CODE CHANGE PROPOSAL

BUILDING CODE COUNCIL

Proposed North Carolina Amendments to 2023 NEC
Prepared by Electrical Adhoc Committee – April 28, 2023

Figure 410.2 Exception Clothes Closet Storage Space Exception

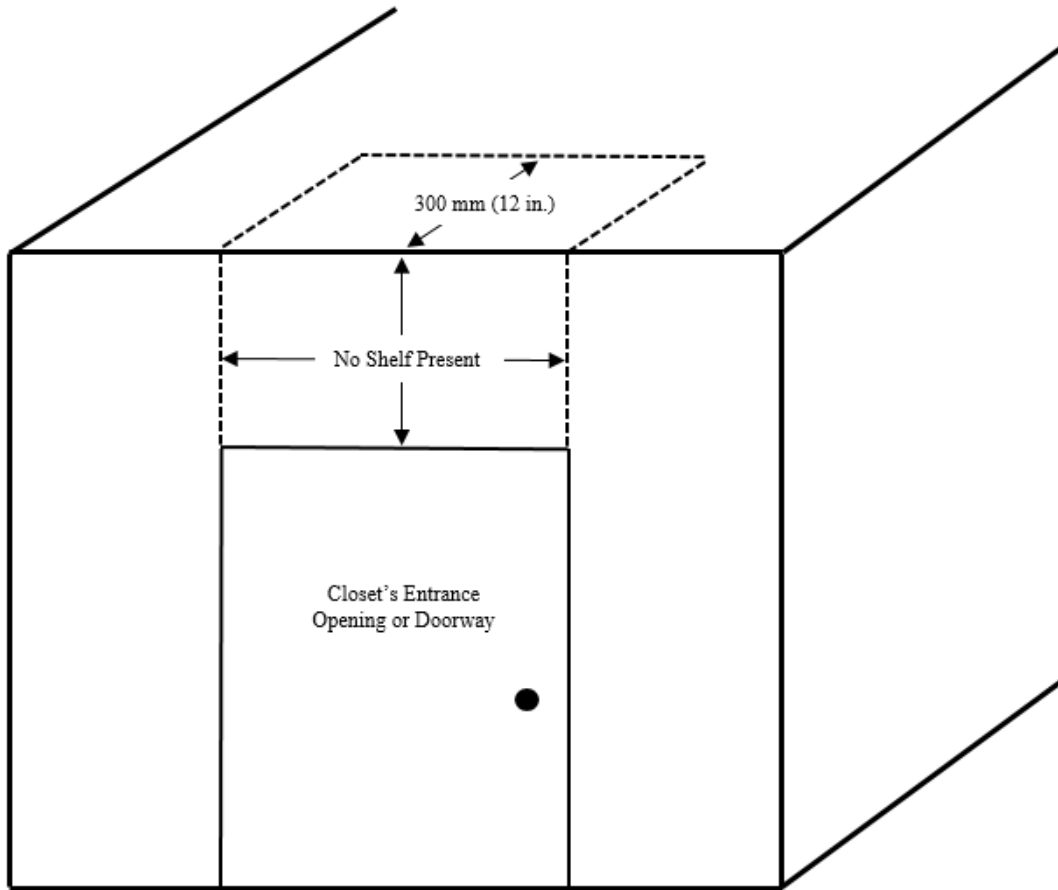
Exception: Where a shelf is not present in the area of wall above the closet's entrance opening or doorway extending from the top of such opening or doorway vertically to the ceiling, including the area of ceiling extending perpendicular from the area of wall directly above the closet's entrance opening or doorway to a horizontal distance of 300 mm (12 in.), shall not be defined as closet storage space. See Figure 410.2 Exception.
